Subject: UniStar Nuclear Energy, NRC Docket No. 52-016
Response to Request for Additional Information for the
Calvert Cliffs Nuclear Power Plant, Unit 3,
RAI No. 65, Seismic System Analysis, Question 03.07.02-6

**Response to NRC Request for Additional Information,
RAI No. 65, Seismic System Analysis, Question 03.07.02-6,
Calvert Cliffs Nuclear Power Plant, Unit 3**

Question 03.07.02-6

Figure 1: Beta (β) Factors for Foundation Impedance Calculations (ASCE 4-98)

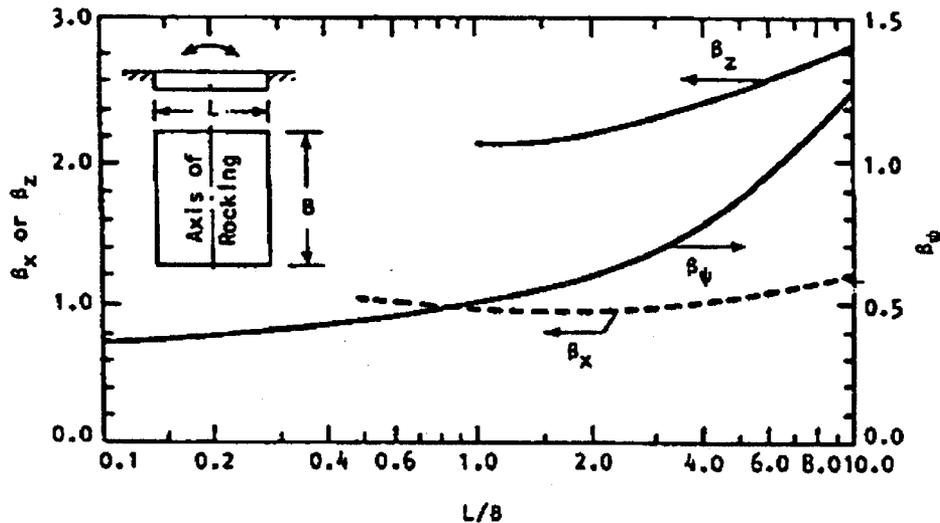
Provide the method and formulas used to calculate the values of the soil springs under the foundation as well as the lateral soil springs that represent the embedment effect.

The soil impedances are calculated per Section 3.3.4.2.2 of ASCE 4-98 (Reference 3 of FSAR Section 3.7.2.16). In this methodology, the foundation impedances are first calculated without considering embedment effects. Table 1 depicts the equations used in this first step, and Figure 1 shows the beta (β) factors required during the calculations. Lateral soil springs are not used at the soil-wall interfaces to represent the embedment effect. The increase in stiffness due to embedment effects is included by multiplying the stiffness coefficients calculated in the first step by the modification factors listed in Table 2. The increase in the damping coefficients due to embedment was conservatively neglected, as stated in FSAR Section 3.7.2.4.
